**UNITED STATES OF AMERICA
NUCLEAR REGULATORY COMMISSION**

Subject: **Docket No. 50-361
Response to Request for Additional Information (RAIs 33, 34, 35, 36, and 55)
Regarding Confirmatory Action Letter Response
(TAC No. ME 9727)
San Onofre Nuclear Generating Station, Unit 2**

SOUTHERN CALIFORNIA EDISON
RESPONSE TO REQUEST FOR ADDITIONAL INFORMATION
REGARDING RESPONSE TO CONFIRMATORY ACTION LETTER

Response to RAIs 33, 34, 35, 36, and 55
(NON-PROPRIETARY)

Figure 1 - AVB Configuration

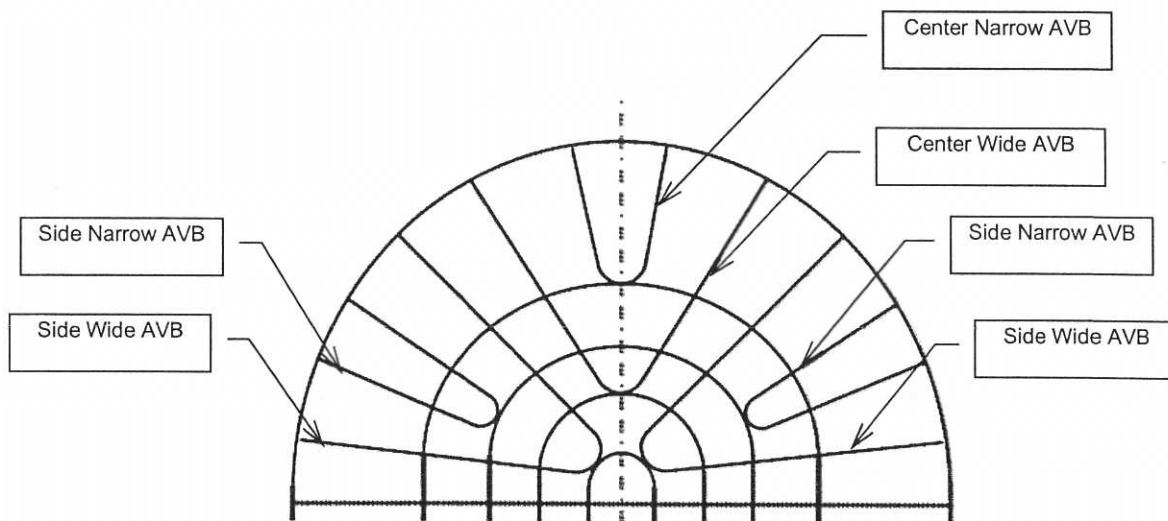
Reference 3, Appendix 9, Attachment 9-3; describe in detail any “tuning” of the contact force model that was performed to replicate the ding signals observed during pre-service inspection.

Three probability distribution functions (PDF) for Side Narrow and Center Narrow AVBs for Unit 2 and Center Narrow for Unit 3 were created from actual distributions of data. (See Figure 1 for Side Narrow and Center Narrow AVBs locations). These three measured PDFs were multiplied by amplification (“tuning”) factors in order to produce eight input PDFs, one for each AVB type in each unit. The amplification factors were adjusted to replicate the ding signals in the pre-service inspections. Figures 2 and 3 show the measured PDFs, amplification factors and the resulting PDFs used as inputs to the contact force models. The resulting input PDFs were the statistical distributions which were actually sampled for Unit 2 and Unit 3.

The following explanation provides details for the input PDFs of each AVB type (Center Narrow, Center Wide, Side Narrow and Side Wide). Unit 2 Center Wide AVB and Side Wide AVB input PDFs were generated from Center Narrow [] ton press measured PDF. The bending angles of the Center Wide and Side Wide AVBs are closer to the Center Narrow AVB bending angle than that of the Side Narrow AVB. For Unit 3, the Center Narrow [] ton press measured PDF was used to generate all Unit 3 input PDFs. Using the Center Narrow AVB only for Unit 3 is reasonable because [] ton press reduces AVB twist scatter such that the twist distribution due to AVB bending angle is negligible.

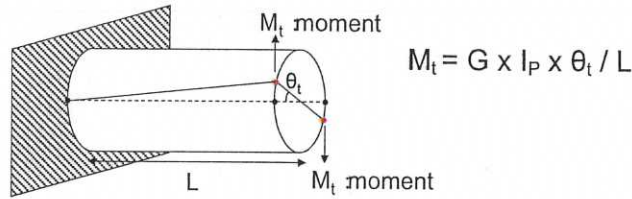
In Reference 3, Appendix 9, page 9-6 (355 of 474) it is also stated, "In AVB nose area, the factor is always 1, because increased twist from nose tip and decreased stiffness from nose tip cancel each other." Please provide a detailed clarification of this sentence. The staff further notes that "twist" and "stiffness" have different units. How can they cancel each other out?

What is the "AVB twist factor?"

AVB twist factor is defined as:

- k₁ is the AVB out of plane spring stiffness due to twist
- k₂ is the radial tube compression stiffness.

AVB Bending Process (Twist Generation)

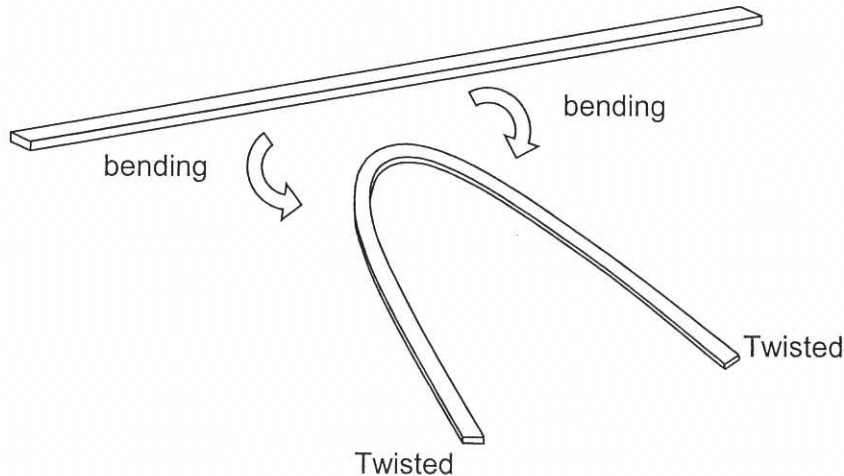
“In AVB nose area, the factor is always 1, because increased twist from nose tip and decreased stiffness from nose tip cancel each other.” Please provide a detailed clarification of this sentence. The staff further notes that “twist” and “stiffness” have different units. How can they cancel each other out?

AVB twist is generated by bending an AVB straight bar during manufacturing as shown in the following figure.

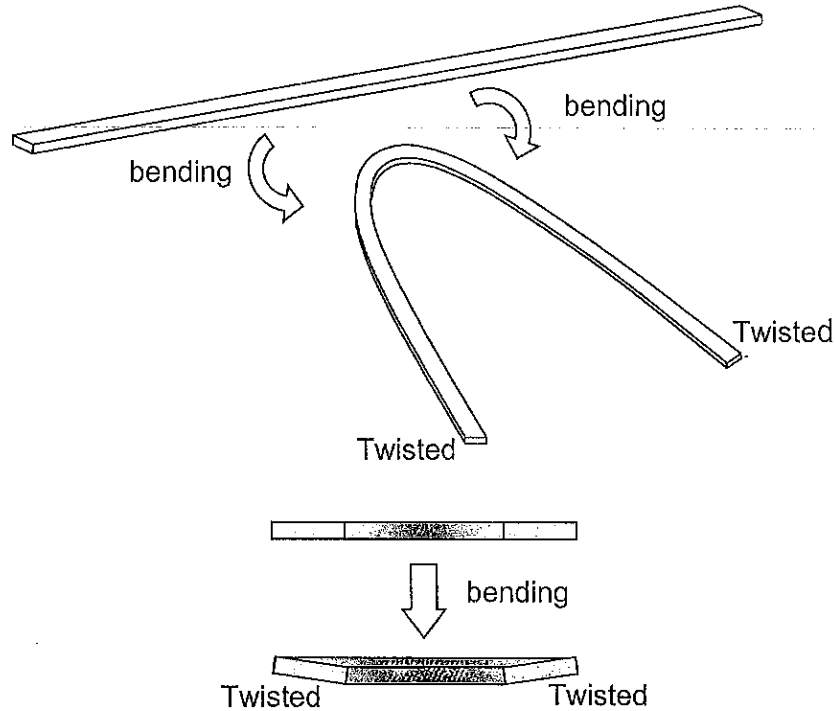
In Reference 3, Appendix 9, Table 6.2-1, which parameters are sampled randomly at each tube/AVB intersection? Why is this appropriate in lieu of assuming a functional relationship for each given parameter from tube to tube in a given column of tubes? For parameters (e.g., AVB twist) assumed to follow a functional relationship from tube to tube in the same column, provide the basis for the assumed relationship. For AVB twist, how does the assumed relationship relate to Figure 6.2-2?

AVB twist was randomly sampled as a property of each AVB, then varied systematically along the length of the AVB using a functional relationship. AVB twist is generated by bending a straight AVB bar during AVB manufacturing, as shown in the following figure. As a result of this process, an unloaded AVB (i.e., before insertion in the tube bundle) has a uniform twist along each straight leg.

Figure 6.2-2 shows the functional form of the AVB twist factor that represents the variation of torsional stiffness along the length of an AVB in the contact force model. Since the AVB has uniform cross section, its torsional stiffness at each tube/AVB intersection along its length is inversely proportional to the distance of the intersection from the nose and retaining bar endpoints of the AVB. This is the reason for the characteristic “bathtub” shape of the AVB twist factor depicted in Figure 6.2-2. For more details regarding the basis for the AVB twist factor, please see the response to RAIs 64 through 66.

Figure 4-13 – Tube-to-Tube Wear Rate as a Function of Wear Index

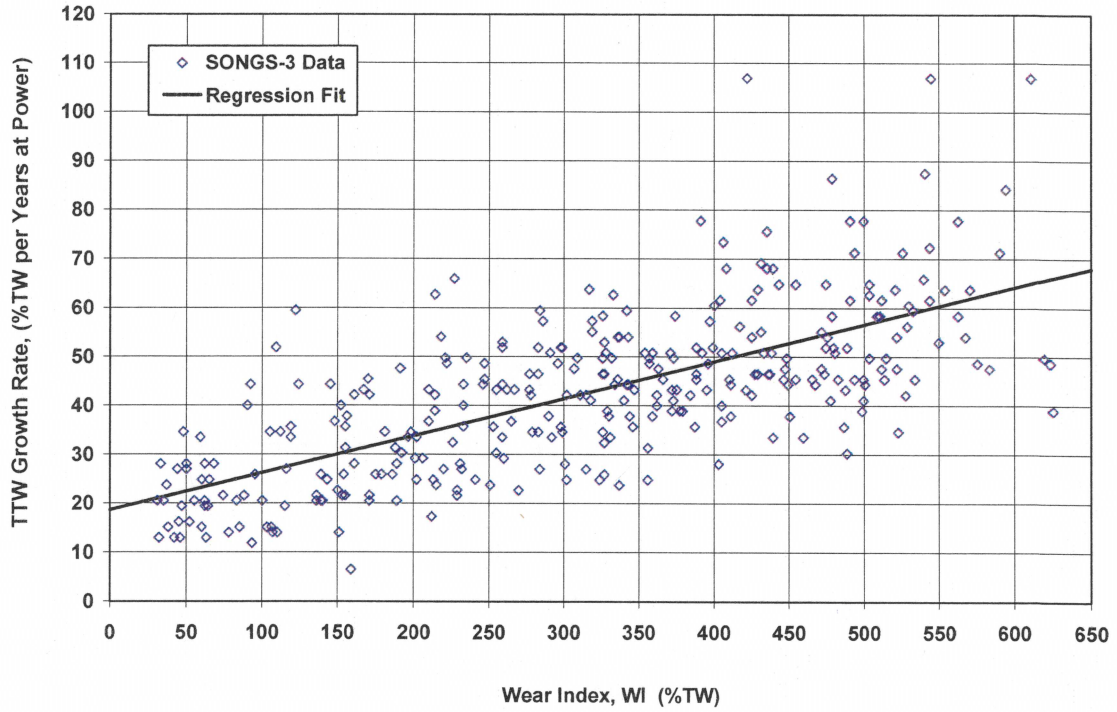
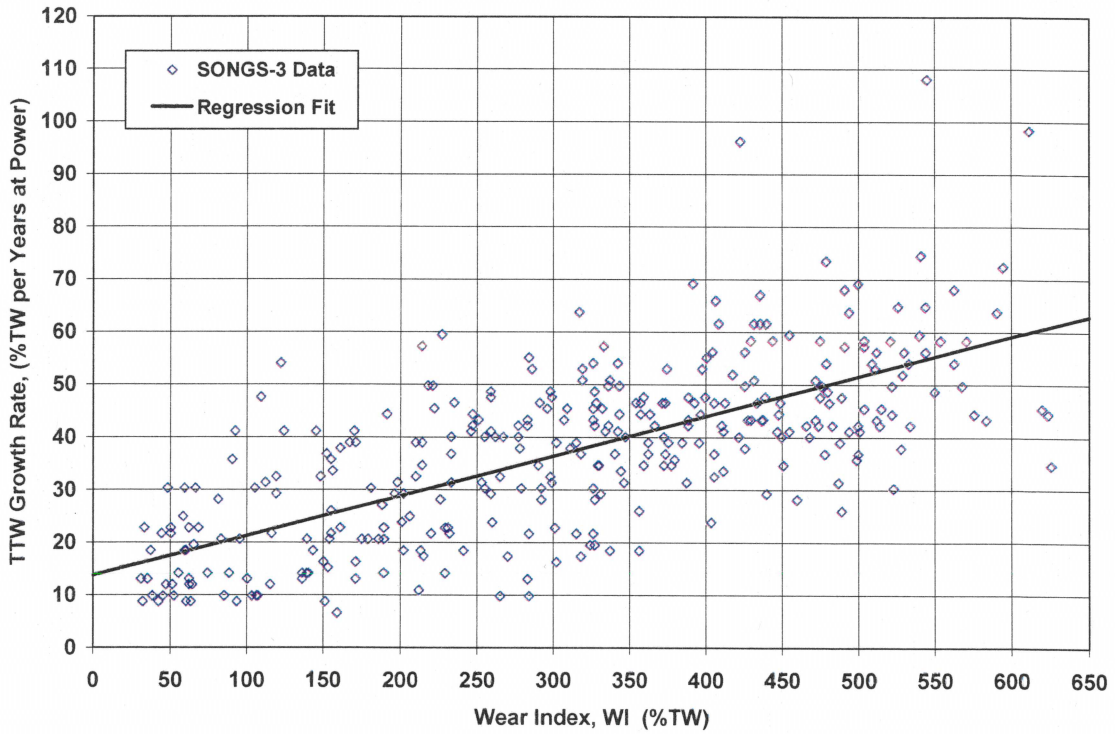
In Reference 1, Figures 4-11 and 4-13, the maximum depths in Figure 4-11 have been divided by the Unit 3 cycle length of 0.926 years to yield the growth rates in Figure 4-13. The staff understands that Figure 4-13 should be simply a scaled version of Figure 4-11. Please explain why some of the data in Figure 4-11 are not shown in Figure 4-13; for example, the three flaws shown in Figure 4-11 with maximum depths ranging from 89 to 100% (AREVA resized).

The wear rates shown in Figure 4-13 were computed by dividing the tube-to-tube wear (TTW) maximum depths by the operating cycle length. The Staff is correct to state that Figure 4-13 is simply a scaled version of Figure 4-11 in RAI Reference 1. A few data points for corresponding wear rates fell above the 100% through wall (TW) per years at power. Figure 4-13 has a vertical axis range of zero to 100% TW per years at power so these points are not seen. Attached are the same graphs in Figure 4-13 with the wear rate axis extended to 120% TW per years at power. The three data points mentioned in the RAI are now visible.
